97-03-13

Model 244RX/GX

Clutch drum and drive shaft

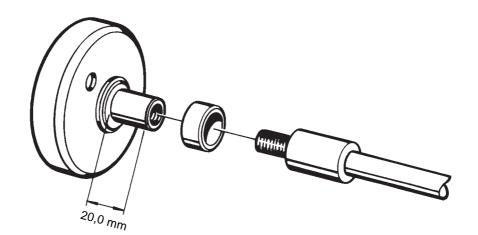
To replace the clutch drum or drive shaft on the model 244, both parts must be replaced at the same time.

We have therefore produced a spare part kit as a replacement. The kit includes the clutch drum, drive shaft and a spacer.

The spacer must be placed on the neck of the clutch drum before it is inserted in the ball bearing in the clutch cover.

The neck of the clutch drum that is included in the kit is slightly shorter than it is on the standard version for the 250.

Ref. No. 502 22 75-01, drive shaft kit – consists of 250 RX drive shaft 502 25 97-03, clutch drum 502 26 31-02, and spacer 502 22 74-01.
